**SUPPLEMENTARY
RESPONSE TO
SUBMISSIONS REPORT
ALEX AVENUE PUBLIC
SCHOOL_SSD_9368**

Associate Director	Alaine Roff
Consultant	Christopher Croucamp
Project Code	P4090
Report Number	Supplementary RTS Report – Final

This supplementary Response to Submissions Report (**RtS**) has been prepared for School Infrastructure NSW (**SINSW**) acting on behalf of the Department of Education (the **Applicant**) in support of State Significant Development Application SSD 19_9368 for 'Alex Avenue Public School' (the **School**).

Figure 1 – Comparison of Site Plan (as submitted with RtS 2) and the Amended Site Plan

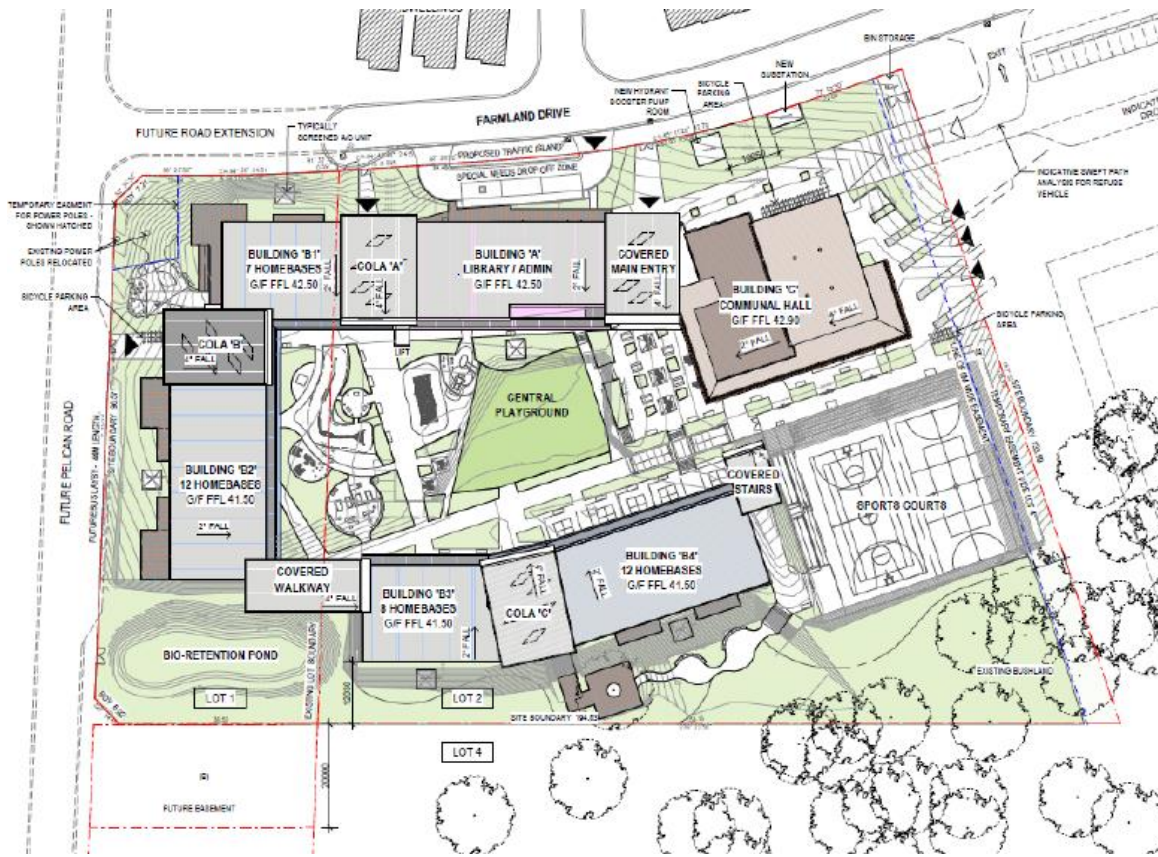
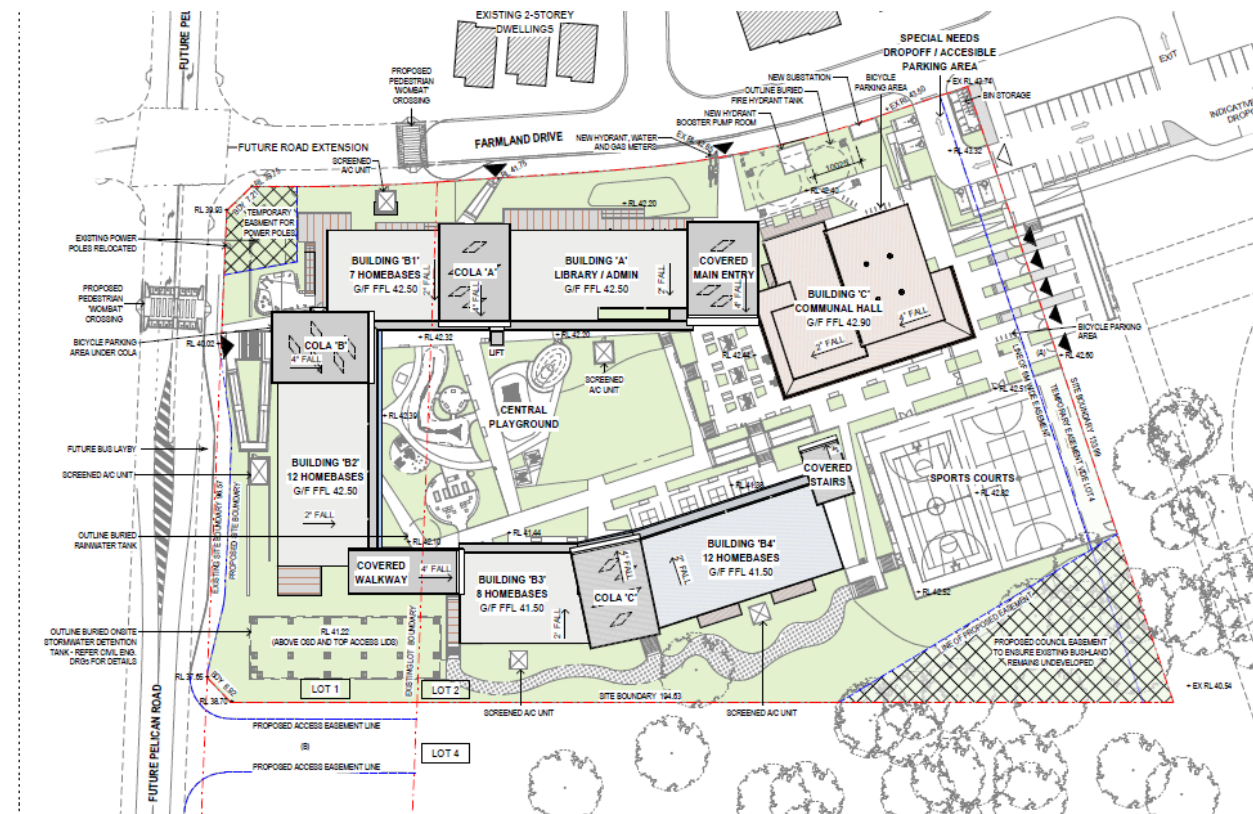
In accordance with Section 55 of the EP&A Regulations, the proposal seeks to make a series of amendments to the proposed development. The amendments are a result of ongoing detailed design development and in response to agency submissions. The following amendments to the previous design are proposed:

- Inclusion of a new wombat crossing on Pelican Road.
- Length of bus bay on Pelican Road has been reduced from 44m to 35m.
- Special needs drop off area has been relocated from the Farmland Drive frontage to north east portion of the site resulting in a change to landscaping along the Farmland Drive frontage.

Figure 5 – Proposed Site and Roof Plan showing Temporary Car Park Arrangement for Stage 1

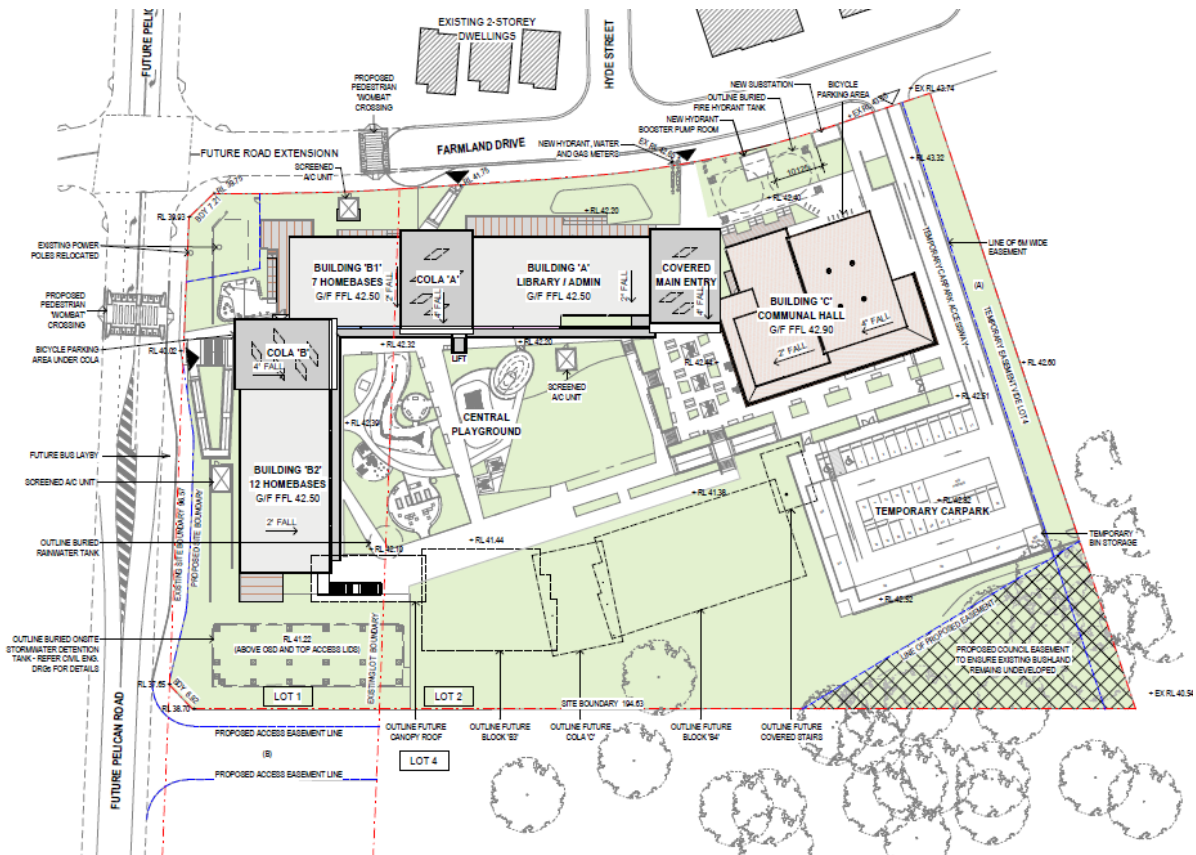
The amended proposal provides a location for temporary onsite staff car parking and drop-off/pick up zone for Stage 1 of the School's operation. Refer to the amended Architectural Plans provided at **Appendix A** for further details. The temporary car park will only be needed if Council does not construct the adjacent car park in time for School opening. It will contain 25 staff car park spaces, 1 accessible parking space, and a drop-off and pick-up zone capable of accommodating up to five (5) vehicle at any time. The temporary carpark, if required, will be located towards the eastern boundary of the site as shown in **Figure 5** below (roughly within the area of the proposed sports courts). It will also accommodate a provisional waste storage area until the temporary Easement A is extinguished, and the bin area can revert to its location near the Farmland Drive frontage.
